# CITY OF ALBUQUERQUE

**Re: Chelwood Elementary School Handicap Parking Spaces  
Grading Plan  
Engineer's Stamp dated 1-07-11 (J22/D005)**

Re: Chelwood Elementary School Classroom Addition Drainage Certification (J22/D5)

**RE: Chelwood Elementary School (J22-D5)**

SHEET TITLE  
TCL REVISION TO REQUIRED  
ADA PARKING SPACES AND RAMP

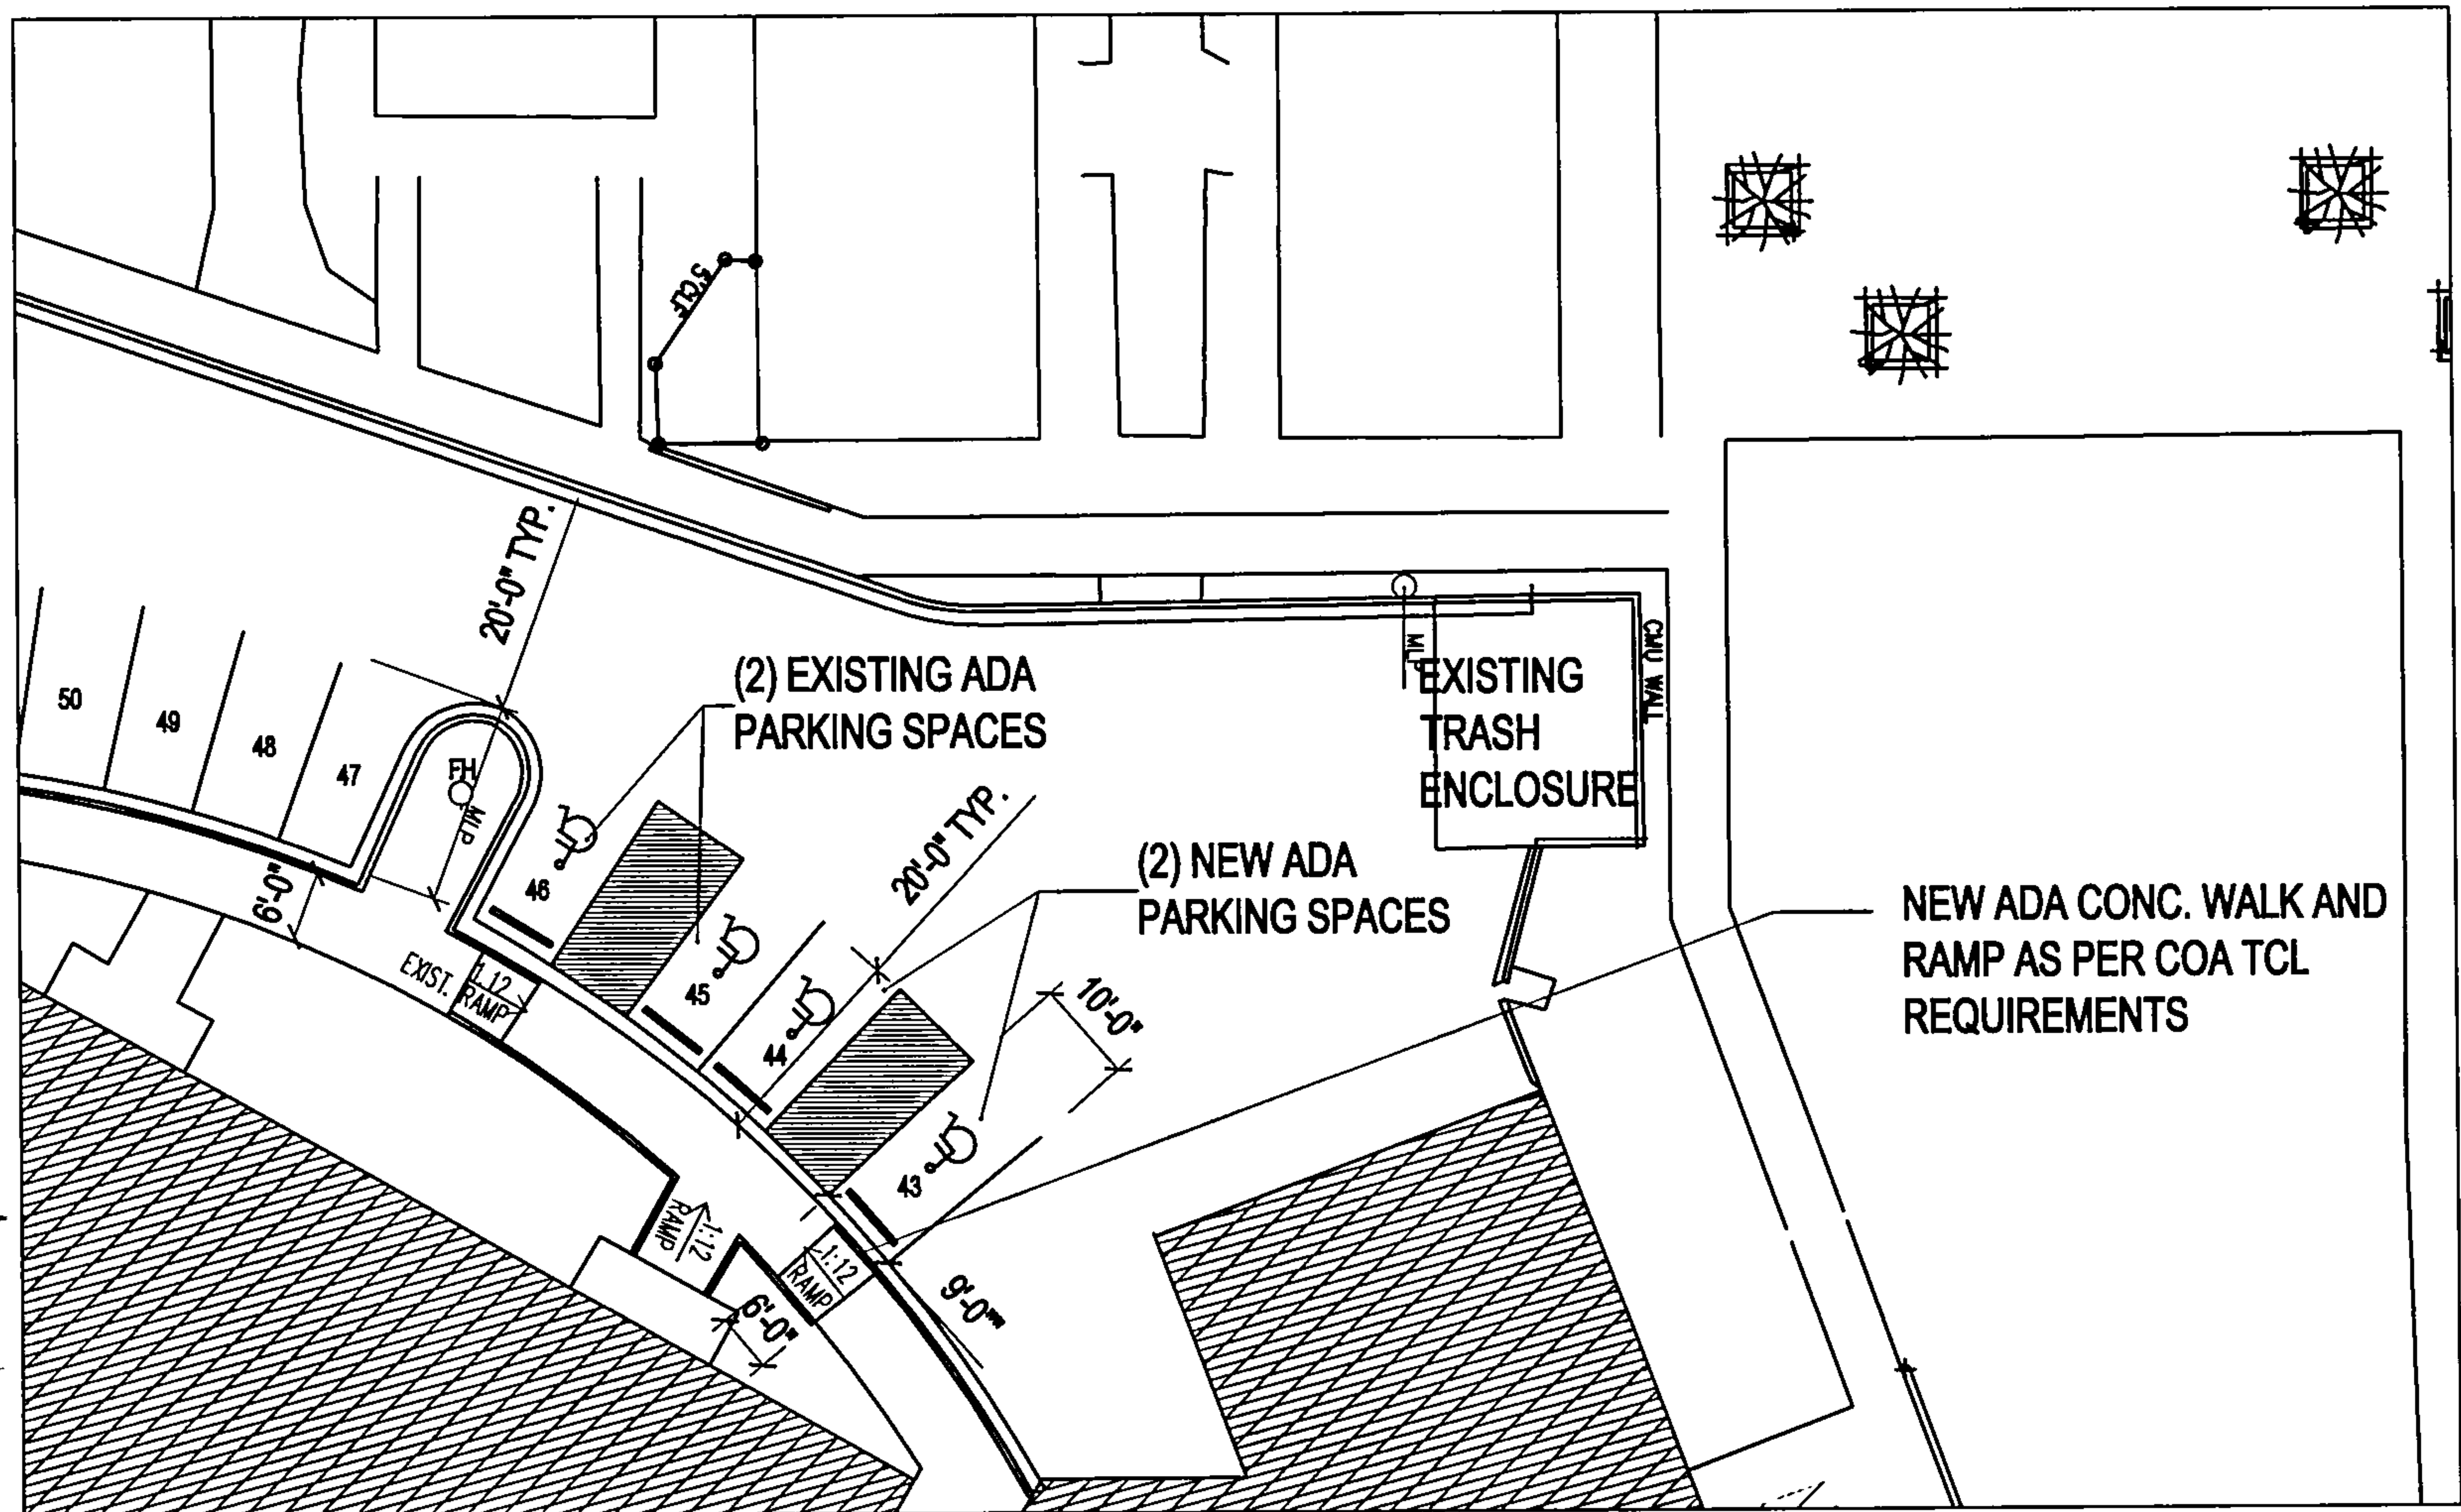
A Temporary C.O. has been issued allowing the H.C. ramp design (need to provide an alternative for ADA access from stall to sidewalk connection) issues to be completed within this time period. When these remaining issues have been fully completed, are in substantial compliance, and a final Certification for Transportation has been resubmitted to the City's Hydrology office for approval, a Permanent C.O. will be issued.

Per your request, and for the purpose of obtaining the final Certification of Occupancy, as the Architect-of-Record I am providing you with this letter certifying that these improvements have been completed by T.A. Cole & Sons (General Contractor) in accordance with the documents prepared by my firm and my Consulting Civil Engineer, Larry Read and Associates, and that the finished construction is in compliance with the jurisdictional requirements. Please see the attached reference drawings and photos, and please don't hesitate to contact us if you have any questions.
